March 6, 1995
Project 0805-131.02

Re: Workplan addendum, ARCO station 6002, 6235 Seminary Avenue, Oakland,
California

ARCO PRODUCTS COMPANY
 SERVICE STATION 6002, 6235 SEMINARY AVE.
 WORK PLAN
 OAKLAND, CALIFORNIA
 PROPOSED WELL LOCATION MAP

FIGURE NO.
1
 PROJECT NO.
 805-131.02

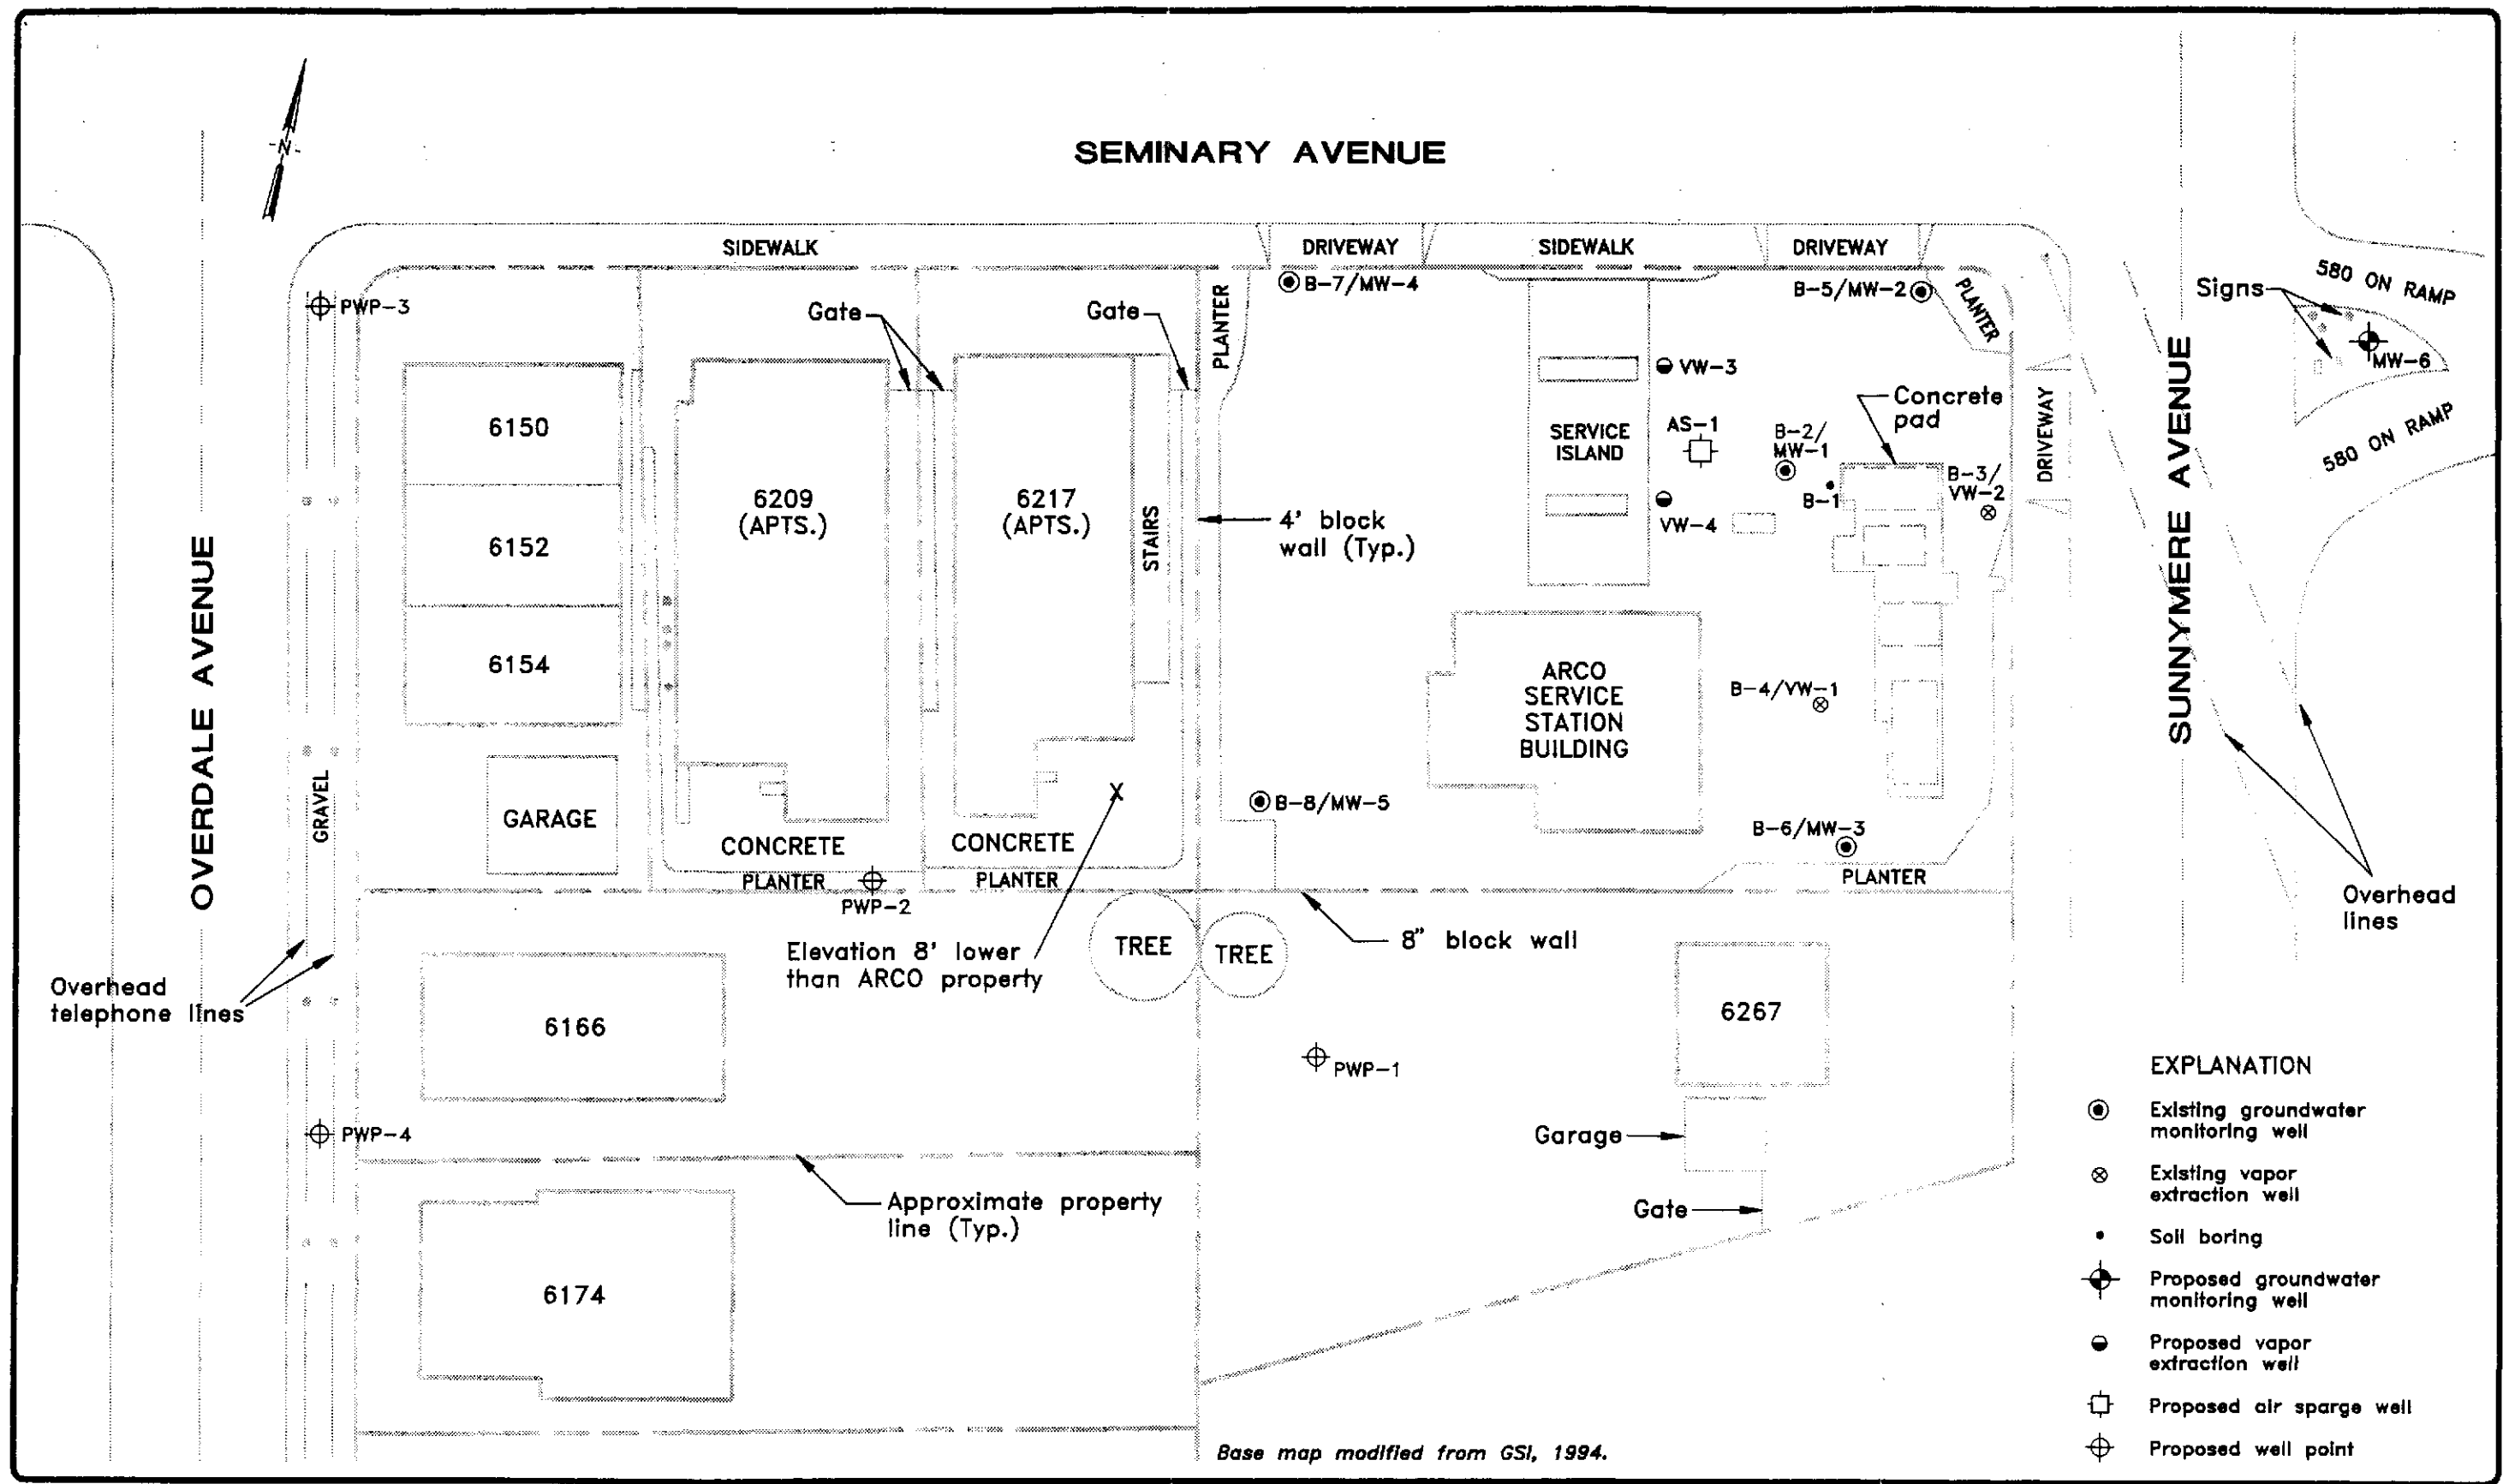
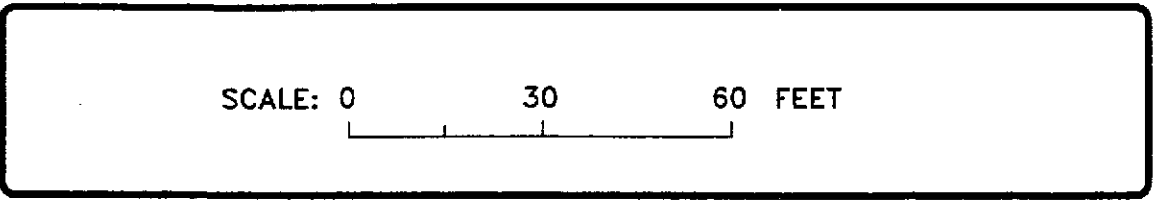
Rq² - Within 45 days of what date
of ~~Project~~ County re the addit. well pts
to an apartment complex west of
site & residential yard
south of site?

Rq² - Why temporary wells & not
permanent wells?

- 1) If weathered gas has been identified in boring B-8 (Well MW-5), could there have been a tank in that location in the past? Also, considering conc. at Well MW-5 higher than other wells.
- 2) The gradient has flowed primarily to the west at the site in the past, so why is Well MW-8 proposed so far to the north? Why are both Well MW-7 and MW-8 proposed over 100 feet from the site? Gradient is steep. why?
- 3) The extent of soil contamination observed in Well MW-5 needs to be delineated, however, it may not be adequately delineated with Well MW-7, which is located so far from the site.
- 4) Are there any utility lines located along Sunnymere Ave. or Overdale Ave that may redirect the flow of ground water? Any beneath the residential area that might?
- 5) A minimum of how many soil samples will be analyzed at a lab? At least one.

- Although gradient to west, why Well MW-5 so high to southwest.
∴ No way of knowing whether 8 + 7 well adjacent address plus

- EMCON will move proposed wells MW-7 and MW-8 to the east side of Overdale Avenue, but proposes to install them as temporary well points rather than permanent monitoring wells (Figure 1). The relocation of MW-7 and MW-8 will decrease the distance between well MW-5 and the proposed well points to approximately 170 feet, allowing a more accurate characterization of the dissolved-phase plume. In addition, EMCON plans to evaluate the technical feasibility of installing temporary well points within the apartment complex west and the residential yard south of the site. EMCON will respond to you regarding these additional well points within 45 days. Based on the depth to groundwater, EMCON proposes to install the well points to a depth of approximately 15 feet BGS. Procedures for installing the temporary well points are presented in Appendix A.
